# AT89C51RB2/RC2

## Silicon Errata and Data Sheet Clarifications

#### 3.3.1 44-Lead TQFP (PT)

#### 44-Lead Plastic Thin Quad Flatpack (PT) - 10x10x1.0 mm Body [TQFP]

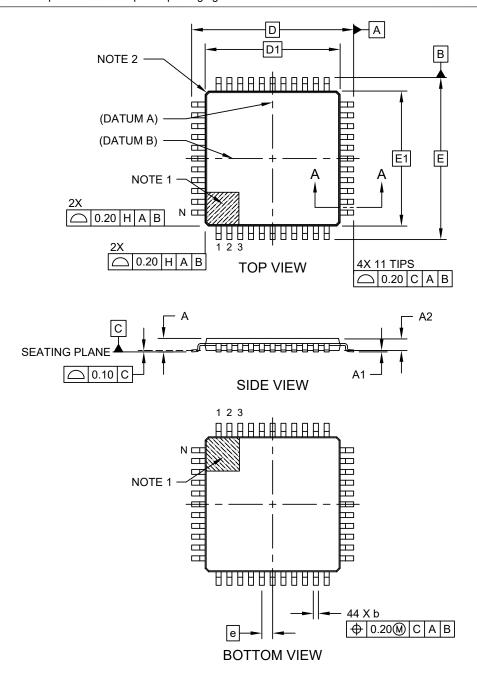
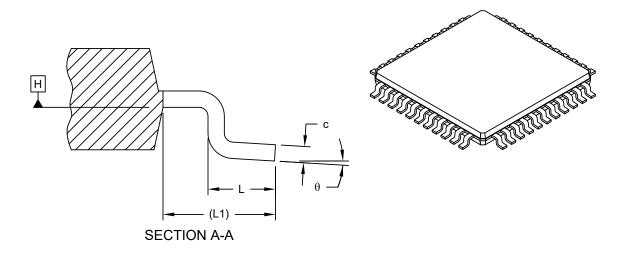
A clarification has been made to replace the VQFP package with a TQFP package.

A drop-in replaceable 44-lead TQFP with the same pinout, footprint, and based on the same die revision replaces the 44-lead VQFP package. There are no functional changes, hence all data sheet specifications are still valid for the replacement CPNs.

The TQFP package outline drawing is shown below.
